Access Compliance Report

Public Rights-of-Way

(Curb Ramps)

Intersection ID: 28381	Main Street: HAWFIELD_WAY_DR	Cross Street: ARDREY_KELL_RD	Location: NE
ADA ID: 26545D620827	Ramp Type: PerpDiag	Initial Pass/Fail: Fail	Overall Compliance: No
		Severity Score: 10

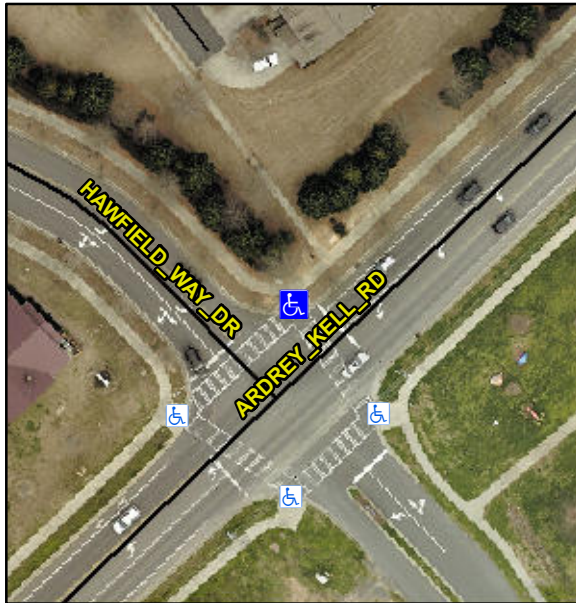
Not Found, R304.5.1, R304.5.3

Compliance	Description	Data	Compliance	Description	Data
N/A	Ramp Length (in)	100.0	Yes	Ramp Slope (%)	6.1
No	Ramp Width (in)	47.0	No	Ramp XSlope (%)	4.2
N/A	Flare Type LT	N/A	N/A	Flare Type RT	N/A
N/A	Flare Slope LT (%)	N/A	N/A	Flare Slope RT (%)	N/A
N/A	Flare Traversable LT?	N/A	N/A	Flare Traversable RT?	N/A
N/A	Landing Length (in)	N/A	N/A	DWS Provided?	N/A
N/A	Landing Width (in)	N/A	N/A	DWS Contrast?	N/A
N/A	Landing Slope (%)	N/A	N/A	DWS Length (in)	N/A
N/A	Landing X Slope (%)	N/A	N/A	DWS Full Width?	N/A
N/A	Landing Curb? (Y/N)	N/A	N/A	DWS Offset (in)	N/A
N/A	Shared Landing?	N/A			
N/A	Gutter Ponding?	N/A	N/A	Gutter Slope (%)	N/A
N/A	Gutter Lip Ht (in)	N/A	N/A	Gutter X Slope (%)	N/A
N/A	Painted X Walk1?	Yes	N/A	Painted X Walk2?	Yes
	X Walk 1 Direction	To SW		X Walk 2 Direction	To SE
N/A	X Walk 1 Width (in)	110.0	N/A	X Walk 2 Width (in)	110.0
	X Walk 1 Slope (%)	0.6		X Walk 2 Slope (%)	5.3
	X Walk 1 X Slope (%)	2.6		X Walk 2 X Slope (%)	4.0

Remove & Replace Curb Ramp With Two New Directional Ramps or Equivalent.
